Type OCS	Model MAGIC	N° T.I. 08 - 2023				
Serial 9023MGCP012082	Subject MODIFICATION OF CAPPUCCINATORE LID	ISSUED FOR (X) <table border="1"> <tr> <td>Action</td> <td></td> </tr> <tr> <td>Information</td> <td>X</td> </tr> </table>	Action		Information	X
Action						
Information	X

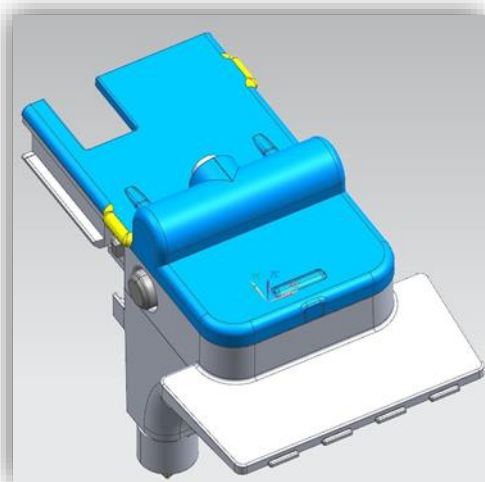
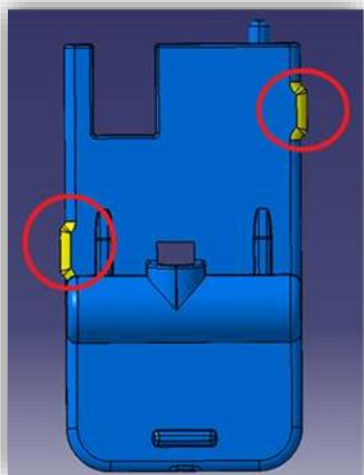
In order to improve the positioning of the dispenser in the machine, we modified the lid of the cappuccinatore by inserting two mold ribs. We have seen that this modification also improves the coupling between the cappuccinatore and the front of the machine, fixing the remaining cases of lack of cappuccinatore presence signal.
